Subject: Remediation Progress Report and Groundwater Treatment Plan for One Hour
Martinizing, 285 East Hampton Avenue, Milwaukee, WI

FID: 241176650
BRRTS: 02-41-543260

OHM
285 E Hampton Ave.
Milwaukee, WI
FID: 241176650
BRRTS: 02-41-543260

Figure	14
Project	6194

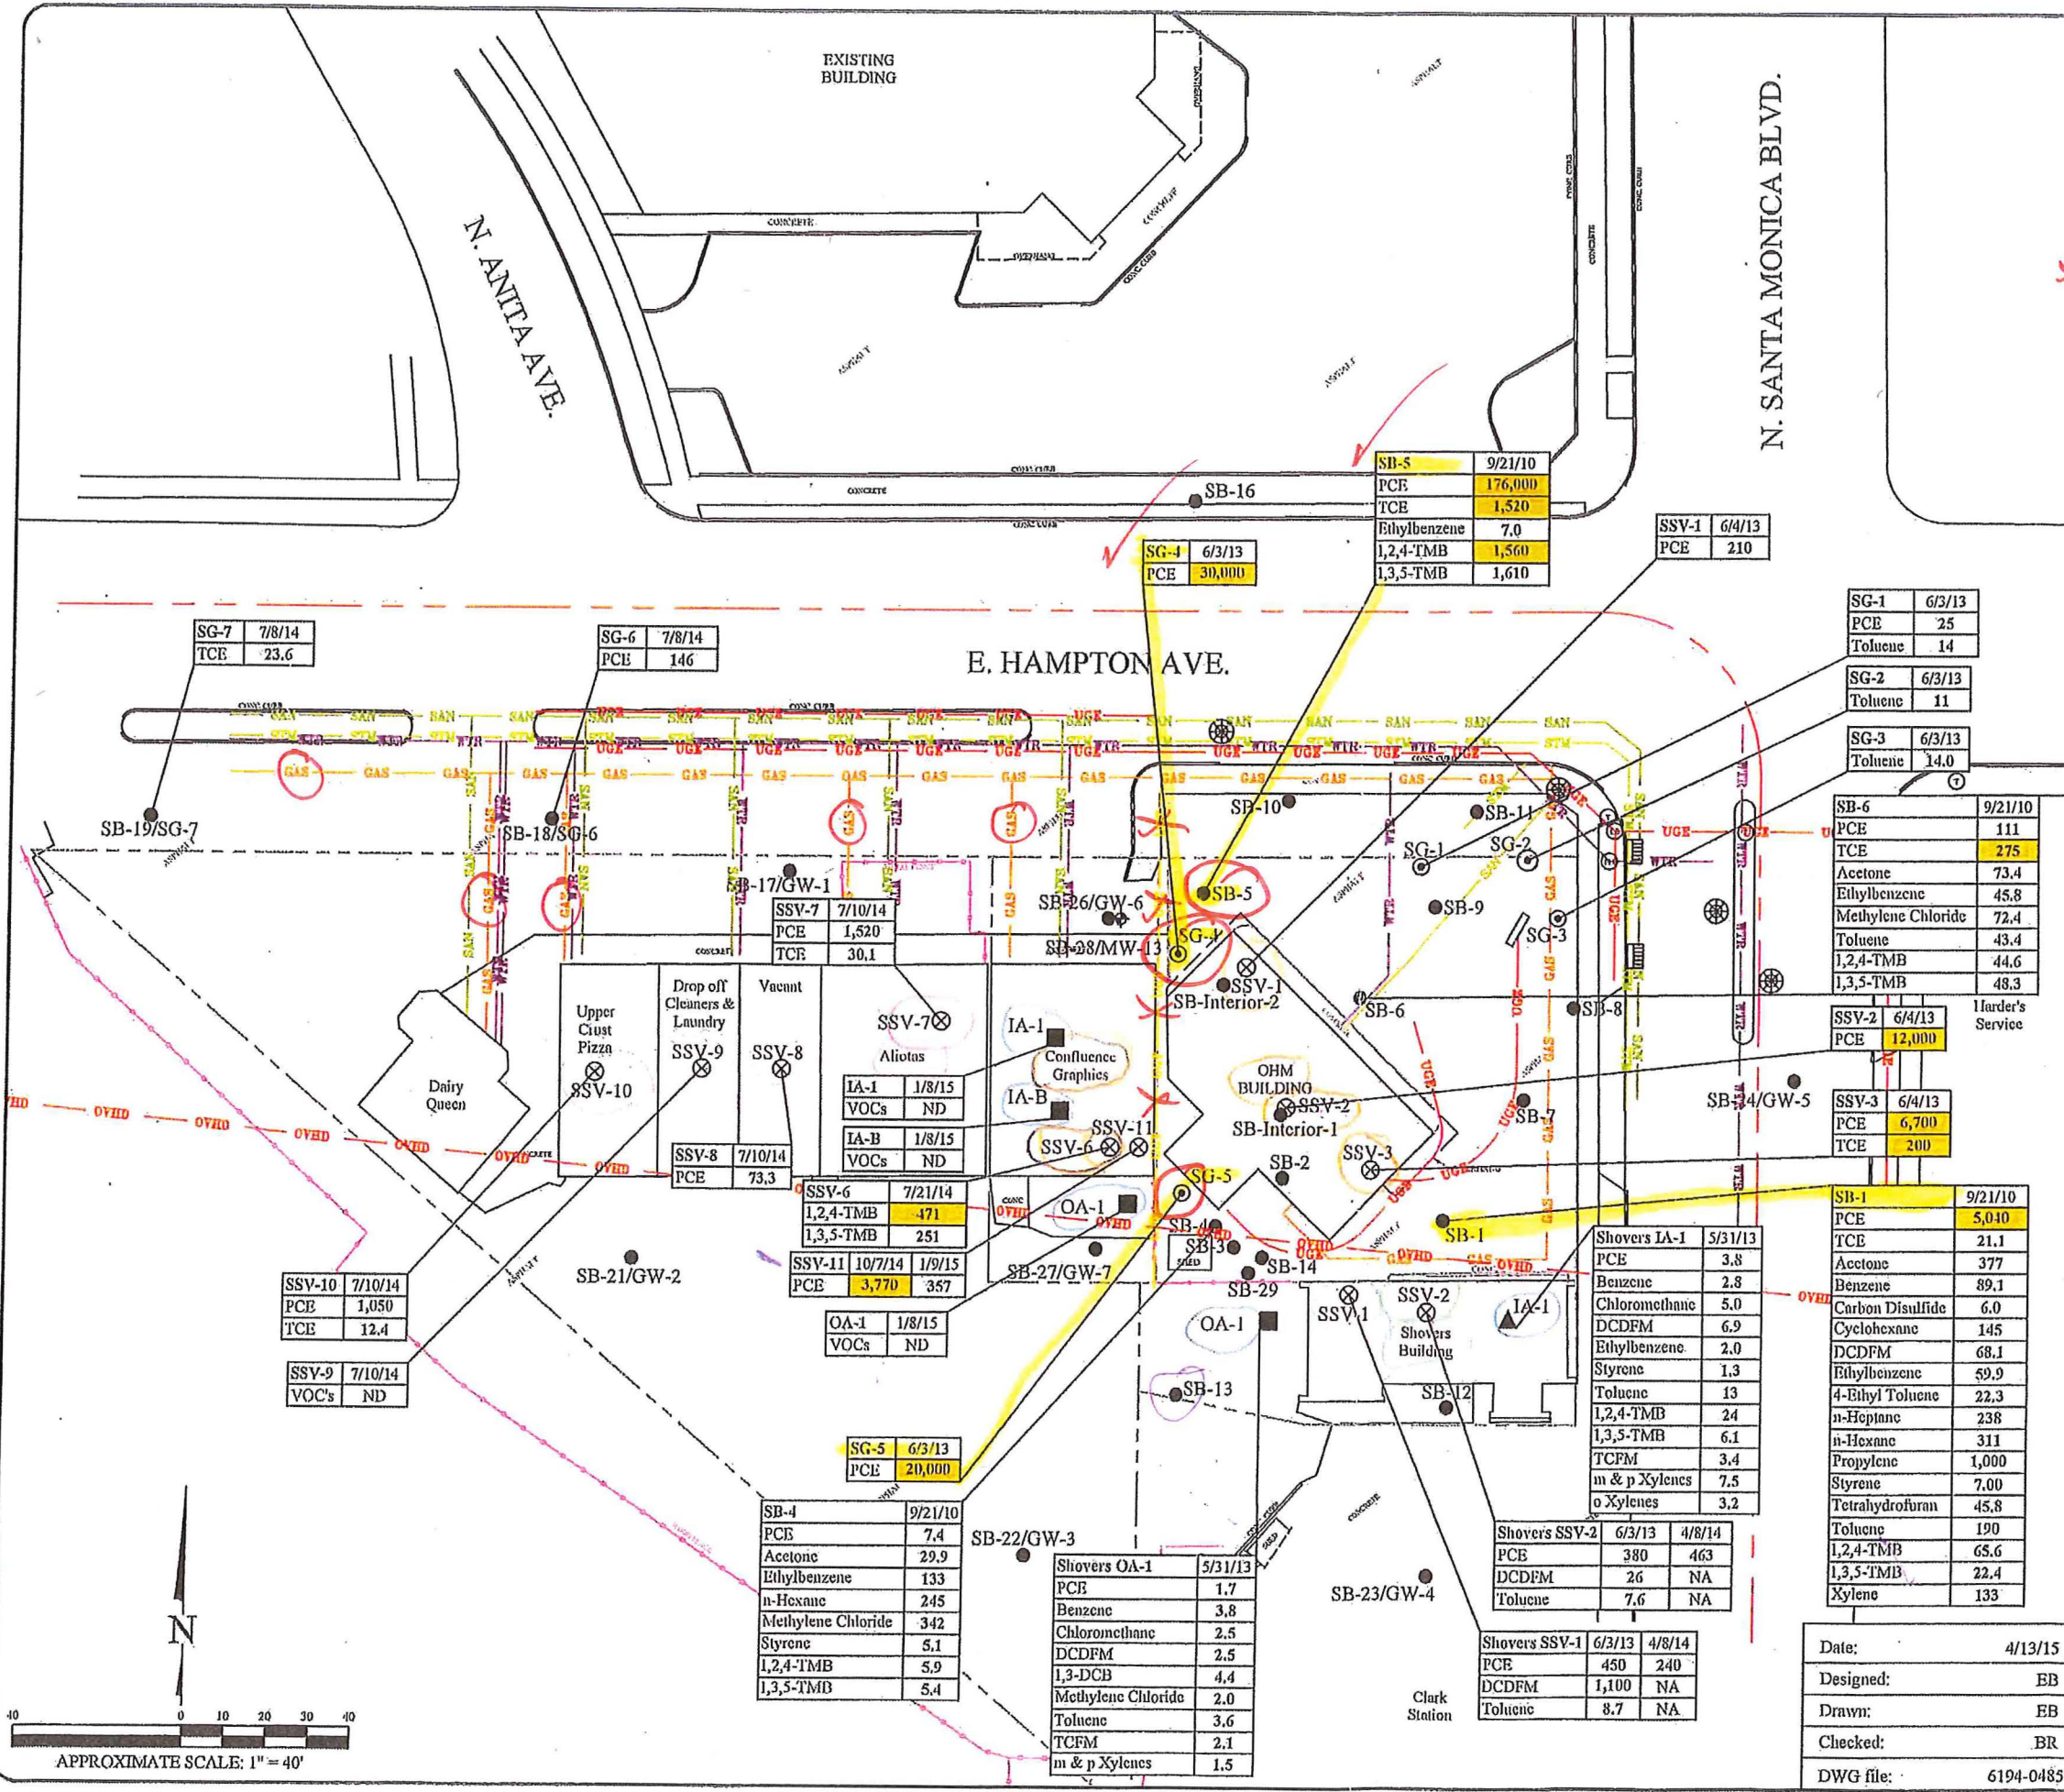
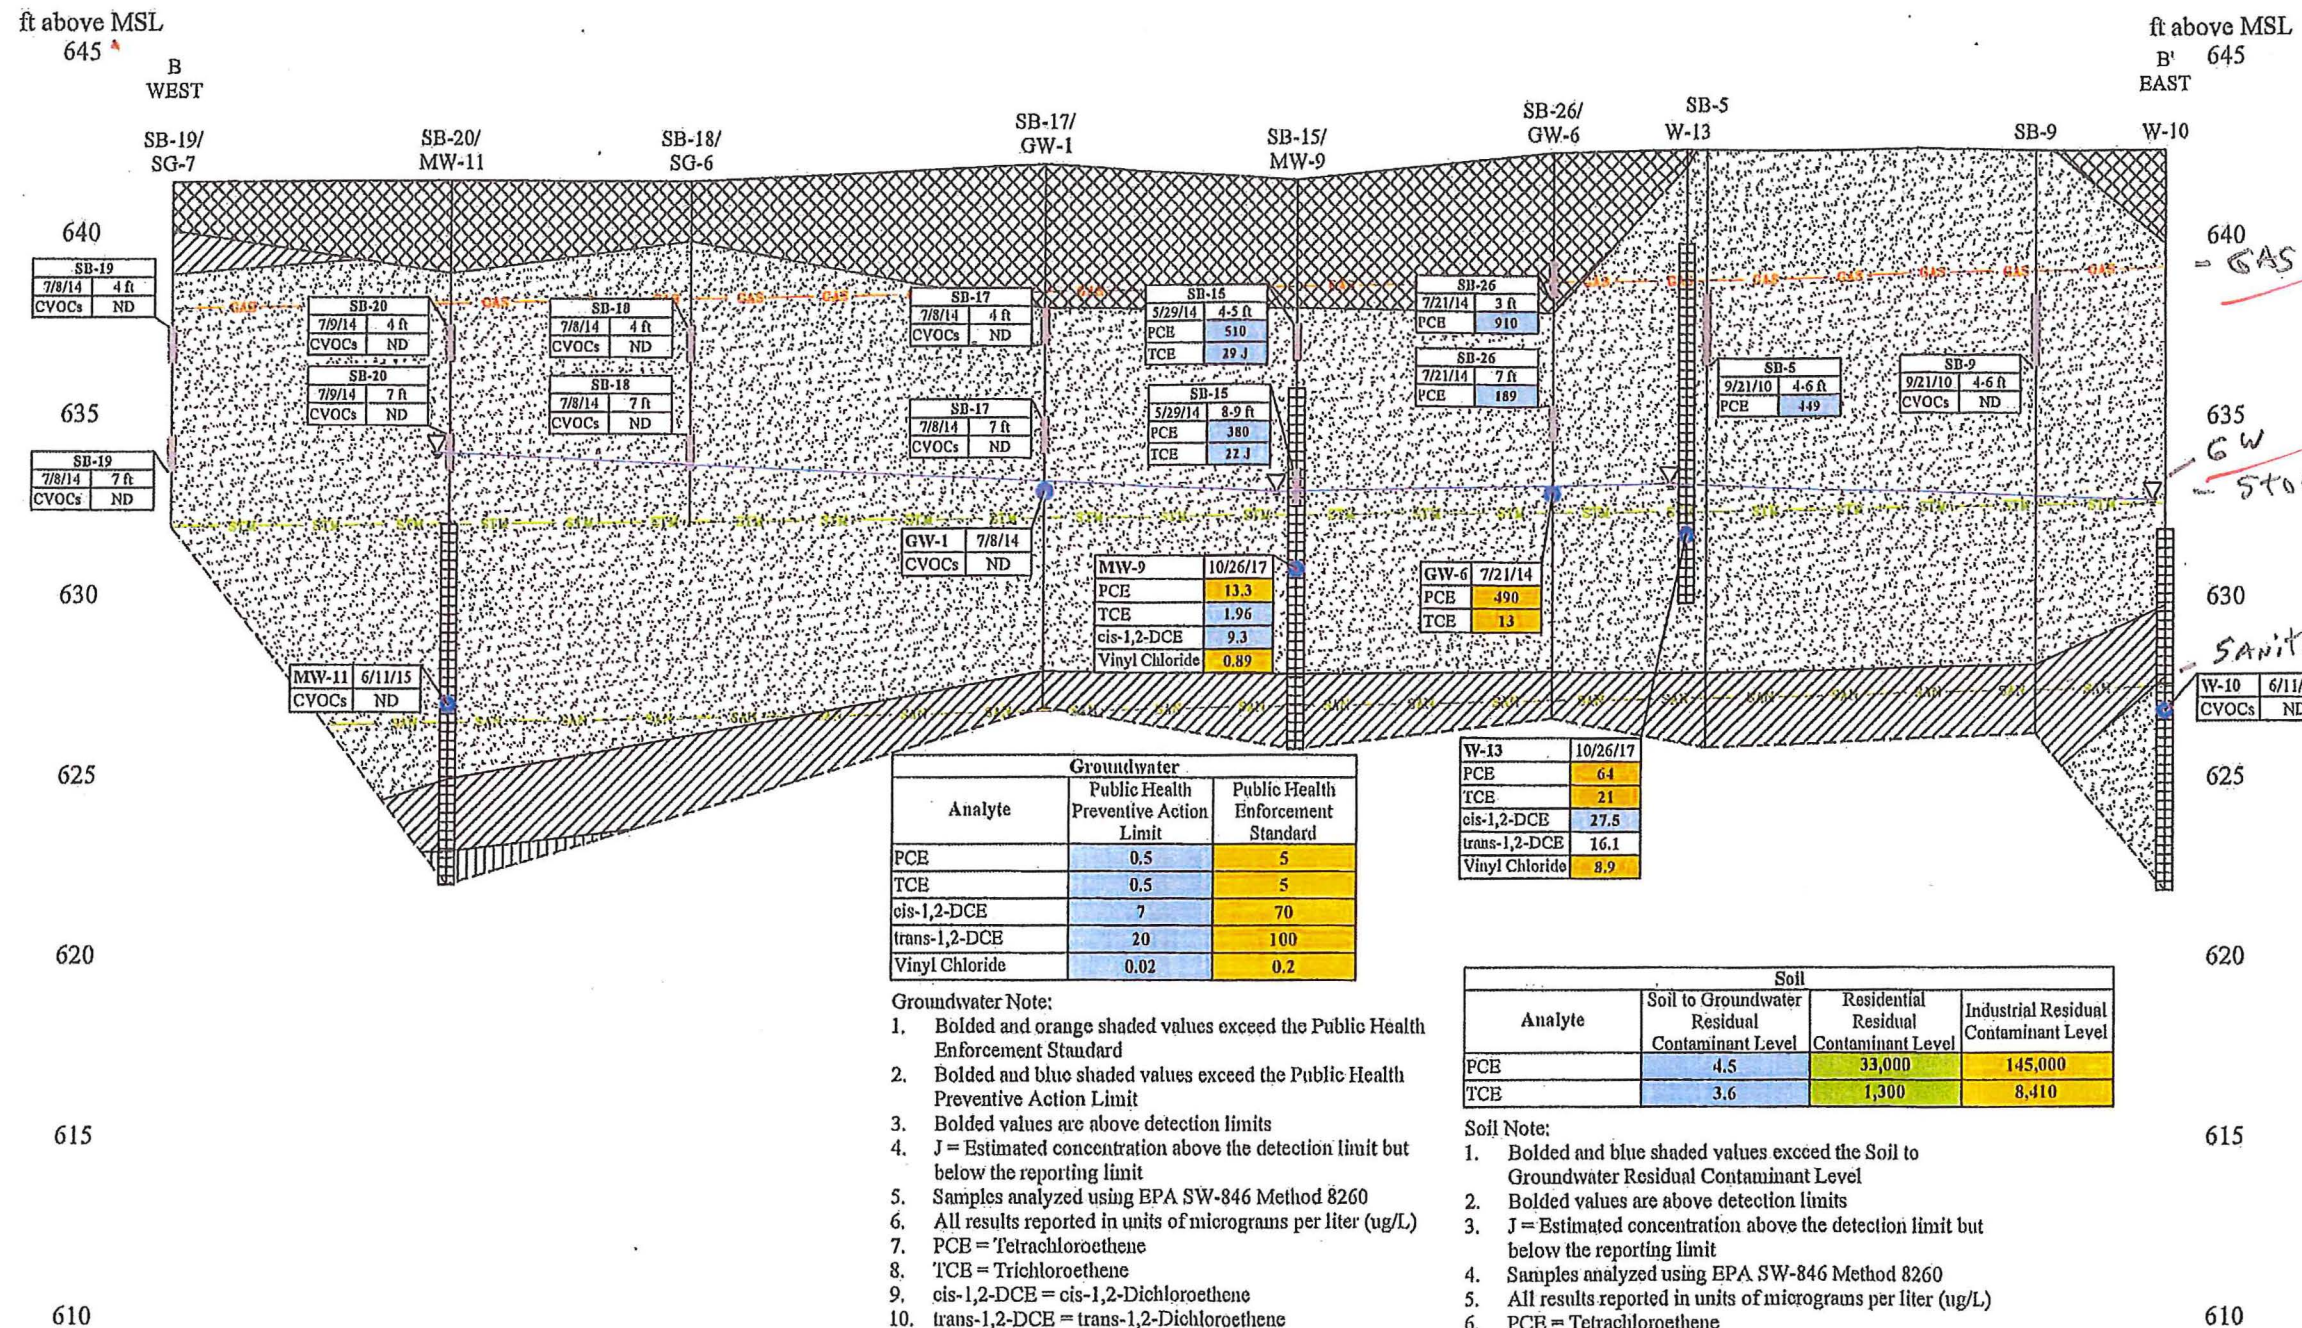
1. An underground fiber optic line runs north-south between the One Hour Martinizing (OHM) and Confluence Graphics buildings. The fiber optic line may intersect the gas and water lines that are located above the groundwater table (see attached Figure 14 and 4) and has the potential to allow vapor migration westward along the gas and water lines. Soil gas locations SG-5 (PCE = 20,000 ug/m³) and SG-4 (PCE = 30,000 ug/m³) are nearest the fiber optic line. Soil data at boring SB-5 (PCE = 176,000 ug/m³ and TCE = 1,520 ug/m³), SG-4, and SG-5 are in areas that aren't near the source area. Determine the source of elevated soil gas and soil contamination in these areas

7. Vapor risk screening levels (VRSLs) have changed since sub-slab and soil gas samples were collected. Revise vapor tables and compare soil gas and sub-slab sample results to current VRSLs. New vapor results figures should be prepared using current standards.

Figure	4
Project	6194

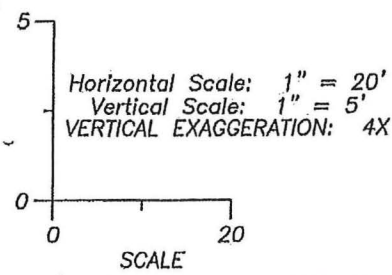
- For Figures 3 (in the report) and 4 (attached), the Residential Residual Contaminant Level heading should be Non-Industrial DC-RCL and the Industrial Residual Contaminant Level changed to Industrial DC-RCL. Correct and resubmit.
- For Figures 8 (in the report) and 9 (attached), change the legend headings as in Figures 3 and 4, and include the soil to groundwater pathway heading. Correct and resubmit.

Figure	9
Project	6194

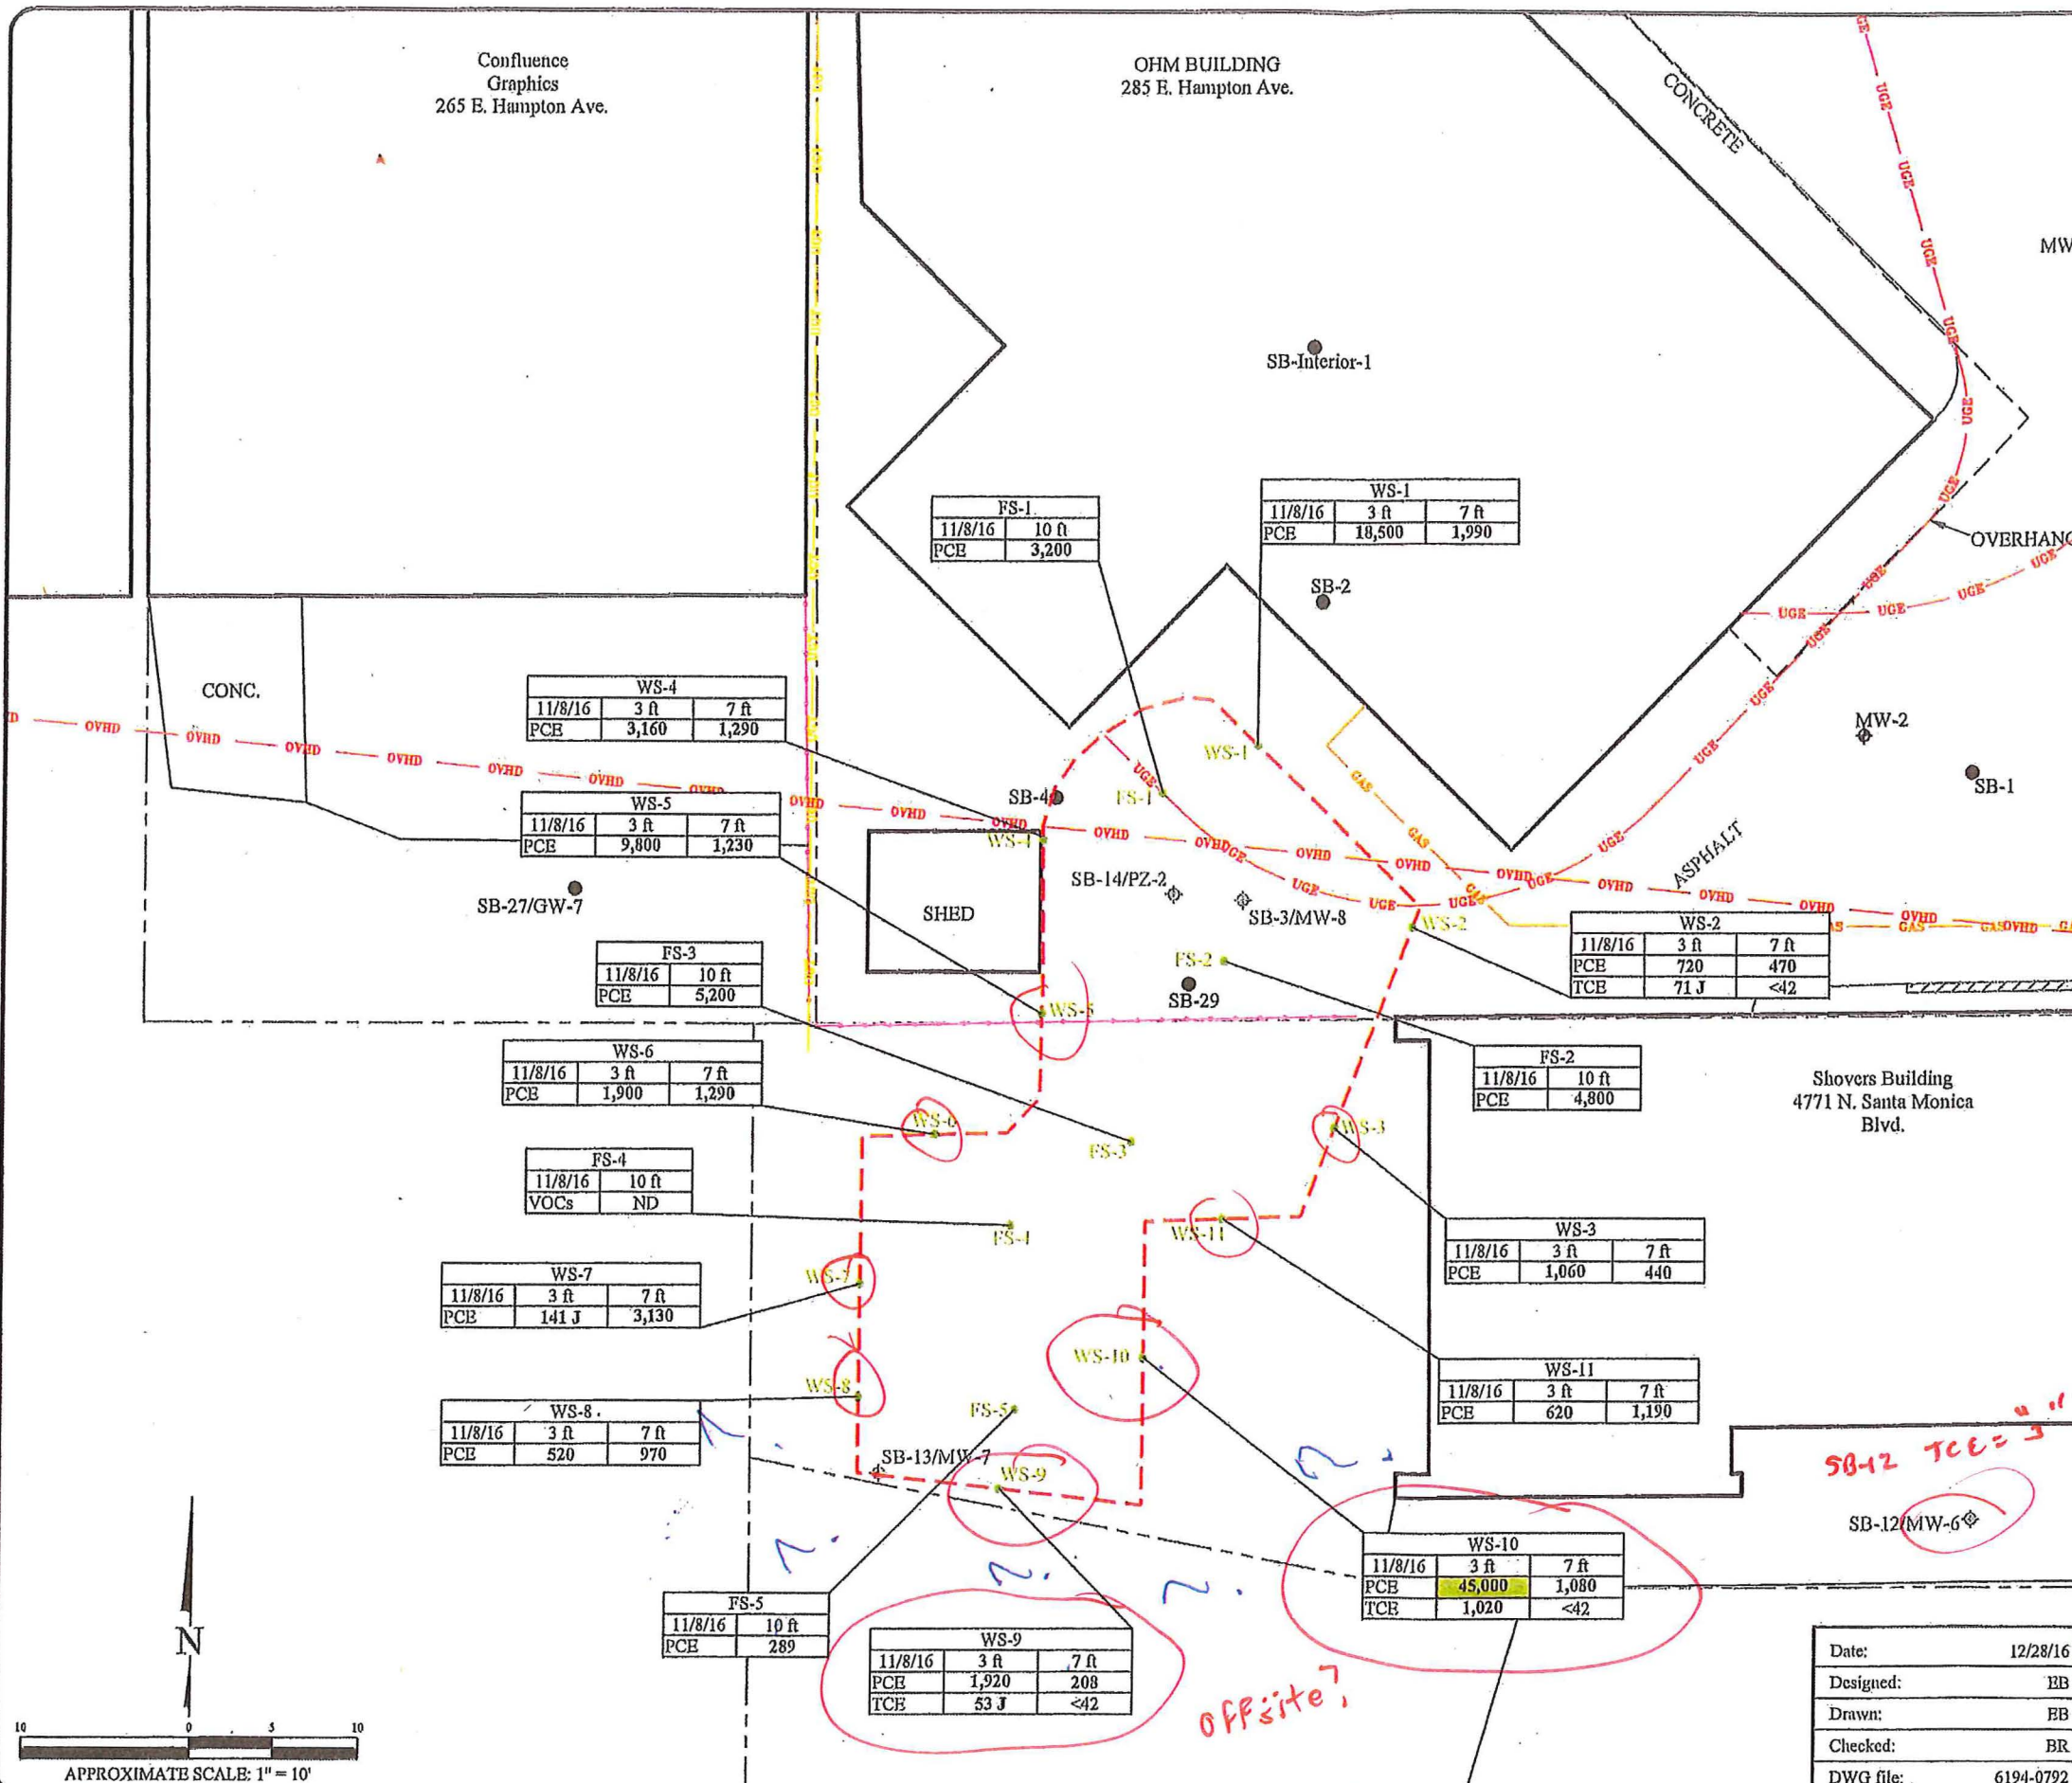
2. High PCE concentrations were identified in the excavation sidewall confirmation samples collected onsite and offsite on the Shovers property and residual solvent contamination extends onto the Clark Station property (see Figure 9). Prepare a figure delineating residual contamination in the source excavation and include sample depth and contaminant concentrations. Clearly identify where the extent is inferred and determine where additional sampling is needed to delineate the extent and degree of contamination offsite at concentrations above residual contaminant levels.
3. Removal of the PCE source in the southern area was part of the remedial action for the site. Enviroforensics has proposed to treat groundwater through injection of an enhanced reductive dichlorination product to reduce the concentrations in the groundwater plume. Because
